Century Mine
American Energy Corporation
In GOD We Trust

RE: Response to Comments, Bennoc Area NPDES OIL00159 Application for American Energy Corporation in Belmont County, Ohio

Response to OEPA Comments from Bruce Goff and Eric Nygaard Dated 8/21/12, 8/15/12, 7/20/12, 7/13/12, and 7/11/12 Bennoc NPDES Permit Application OIL00159

Unnamed tributary 23 downstream view of physical habitat

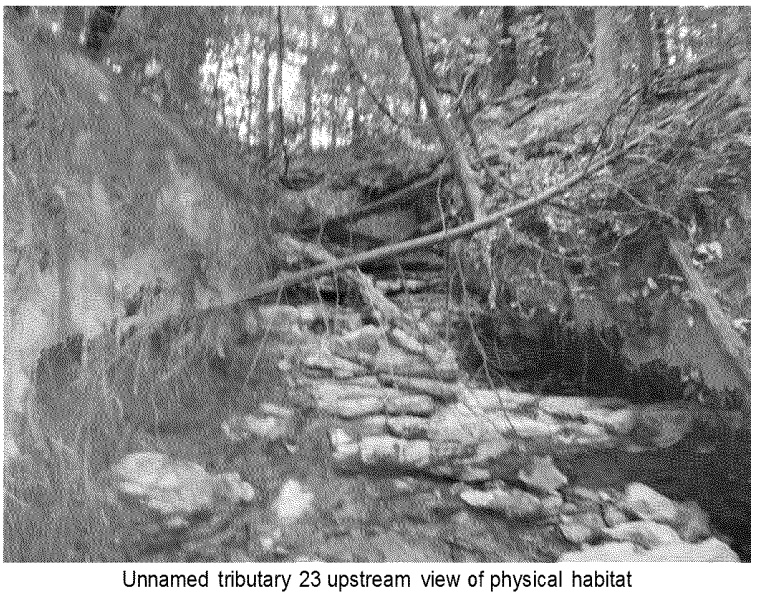
Comment: I don't know if would be on any use to us to help with permitting, but if you can have your biologists look at the two small tribs that both ponds discharge into and evaluate their potential for aquatic life use, that may be helpful.

Response: A field investigation was completed on July 13, 2012. The results of this investigation can be found in the attached report, "Investigation of Unnamed Receiving Tributaries to Piney Creek."
